SUBJECT: Requests approval by Mar 1980 of encl proposed heatup & cooldown curves for 5-10 effective full power years, submitted 770420.

Re: Turkey Point Units 3 & 4
Docket Nos. 50-250 and 50-251
Proposed Amendment To Facility Operating Licenses
DPR-31 and DPR-41

FIGURE 3.1-2d TURKEY POINT UNIT 4 REACTOR COOLANT COOLDOWN LIMITATIONS APPLICABLE FOR PERIODS FROM 5 TO 10 EFFECTIVE FULL-POWER YEARS.

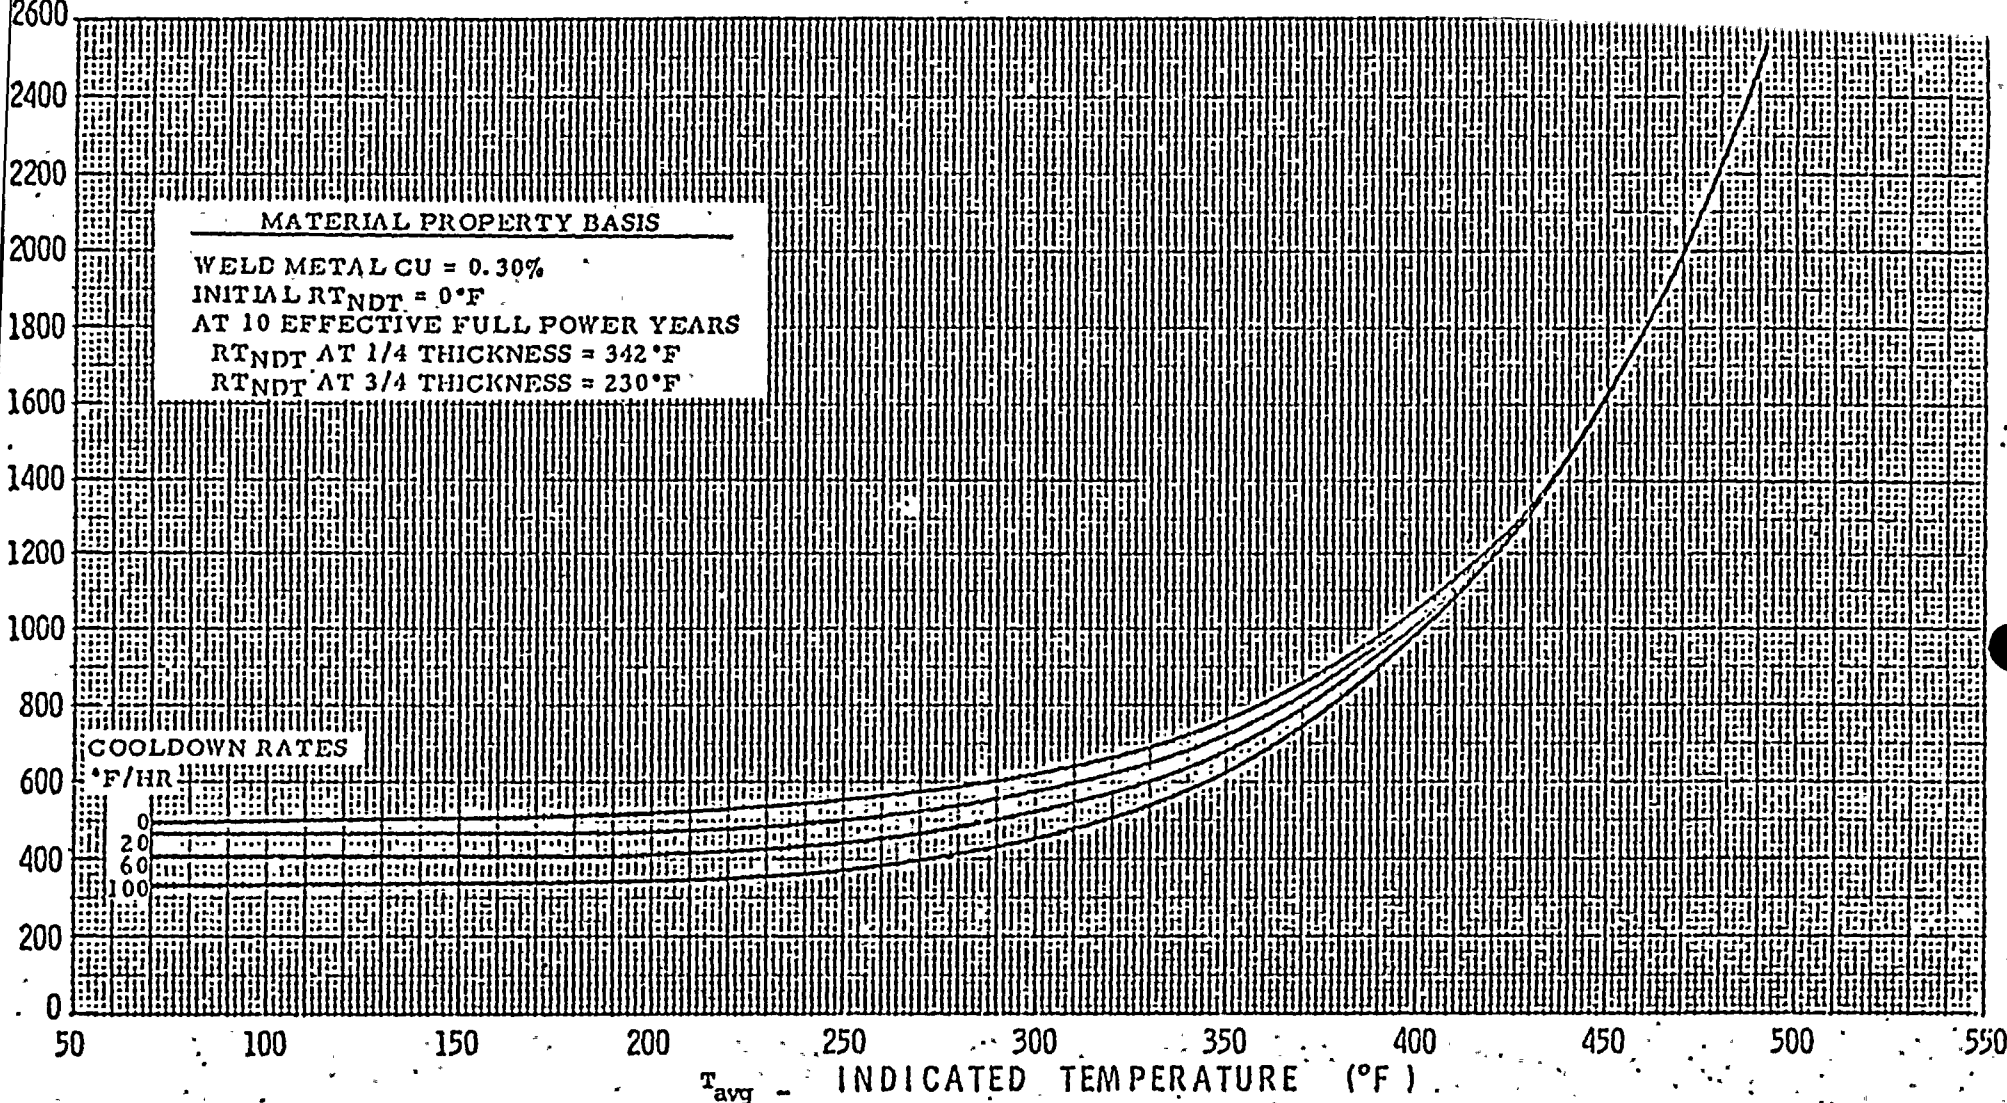
Florida Power & Light Company estimates that Turkey Point Unit 3 will reach 5 EFPY by April 1980. We therefore request that our proposed heatup and cooldown curves for the period from 5 to 10 EFPY which we submitted on April 20, 1977 be approved prior to March 1980. A copy of the proposed curves are attached for your convenience.
